1 Q. It is understood that the 200ms shutdown time for a three phase or single phase
 2 short circuit in the ac network near Soldiers Pond and near Muskrat Falls is based
 3 on the use of a dual protection system. Please explain what would happen if the
 4 breaker does not open, e.g. due to a breaker failure and the consequence on the
 5 power supply to the Island Interconnected System including whether load shedding
 6 will be required and if so, what magnitude of load shedding would be required.

Island Interconnected System Supply Issues and Power Outages

MUSKRAT FALLS AC SWITCHYARD 315 kV SINGLE LINE DIAGRAM

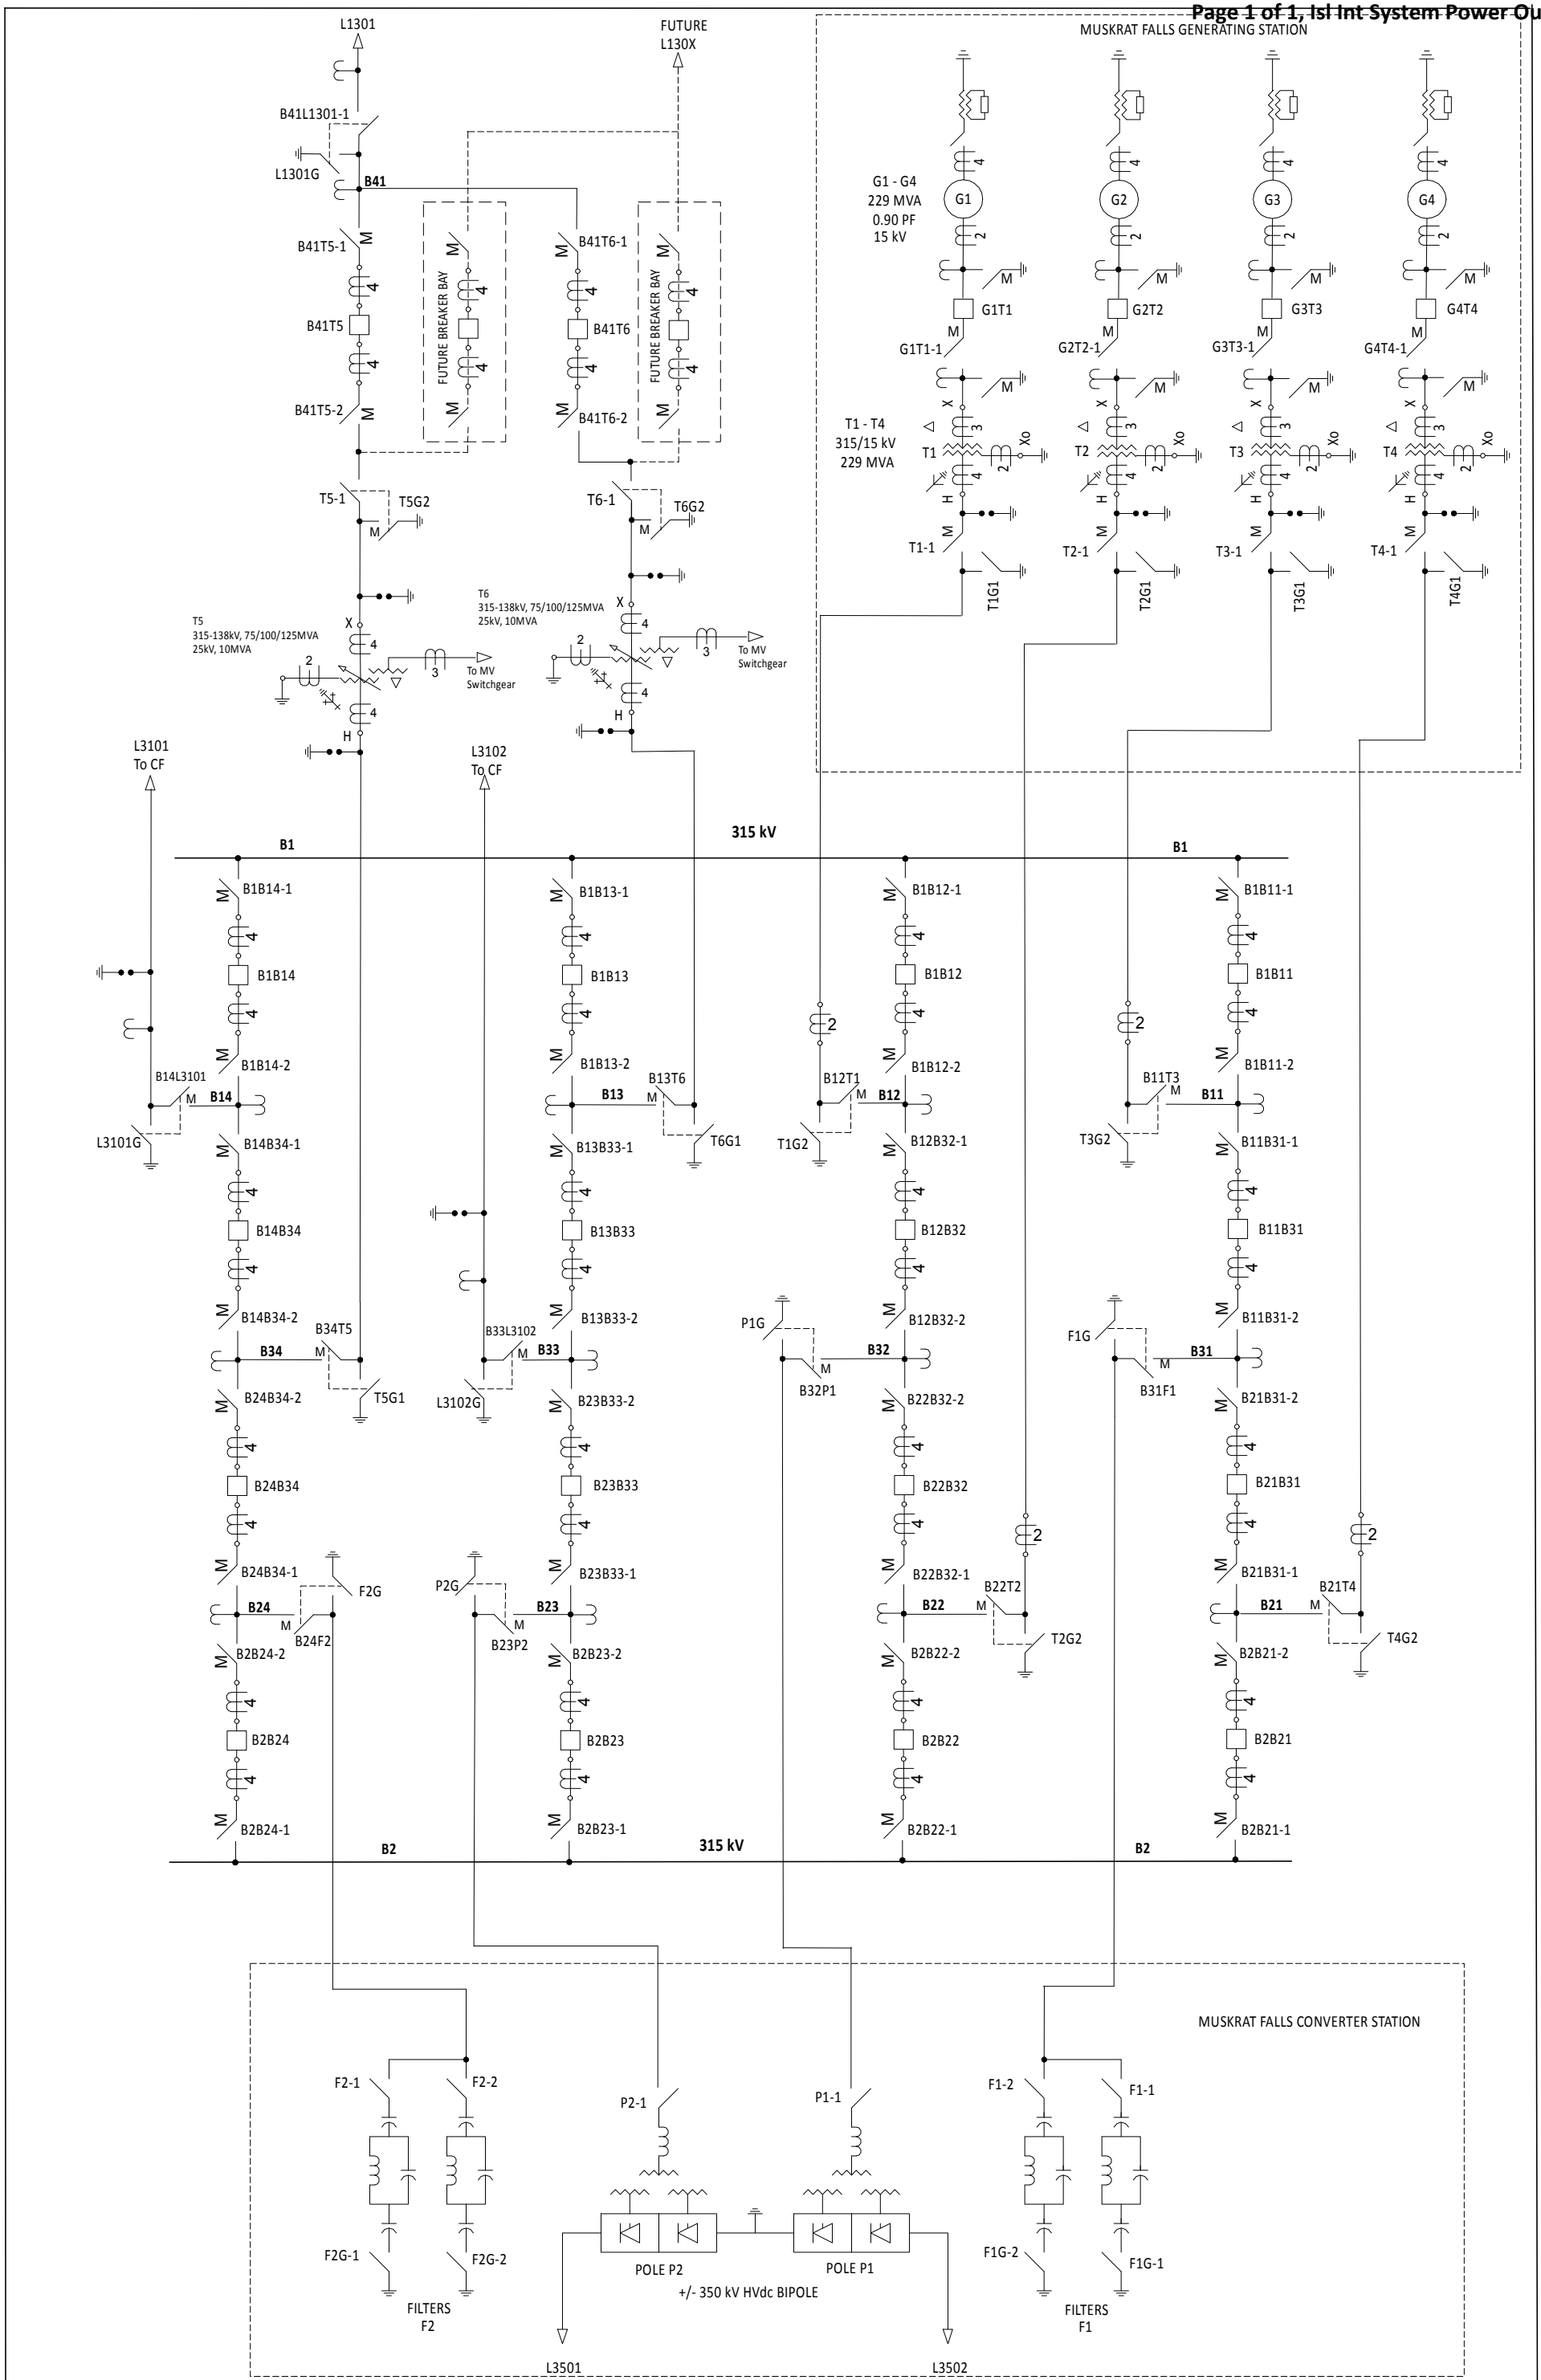
1 Tables 2 and 3 outline the equipment forced out of service at the Muskrat Falls and
 2 Soldiers Pond switchyards, respectively, for a three phase fault with stuck breaker
 3 protection operated to clear the fault. Please refer to attached single line diagrams
 4 (PUB-NLH-241 Attachments 1 and 2) for clarification.

Table 2: Muskrat Falls ac Switchyard - Local Breaker Fail Protection

Case	Faulted Bus	Failed Breaker	Forced Equipment Outages	
1	B12 or B32	B12B32	G1	P1
	B32 or B22	B22B32	G2	P1
2	B11 or B31	B11B31	G3	F1
	B21 or B31	B21B31	G4	F1
3	B24 or B34	B24B34	T5	F2
4	B14 or B34	B14B34	T5	L3101
5	B34	B41T5	T5	L1301
6	B23 or B33	B23B33	P2	L3102
7	B13	B41T6	T6	L1301
8	B13 or B33	B13B33	T6	L3102

In the event of a breaker failure, a breaker adjacent to the failed unit will trip in 200 to 300ms.

1 The dynamic analysis has indicated the worst-case stuck/failed breaker scenario is a
2 fault on Muskrat Falls bus B23 or B33 with a stuck circuit breaker resulting in the
3 trip of both an HVdc pole and a 315 kVac transmission line (i.e., L3102) between
4 Churchill Falls and Muskrat Falls during winter peak operation. This is case 6 in
5 Table 2 “*Muskrat Falls ac Switchyard - Local Breaker Fail Protection*” above. In this
6 case the converter station at Muskrat Falls will experience multiple commutation
7 failures and does not recover. For this scenario, the HVdc protection would trip
8 both poles of the Labrador Island Link resulting in a total loss of supply from
9 Labrador. This case can be considered a permanent bipole failure, and as such, is
10 expected to result in scheduled load shedding on the Island Interconnected System.
11 The detailed load shedding schedule is to be developed during the operational
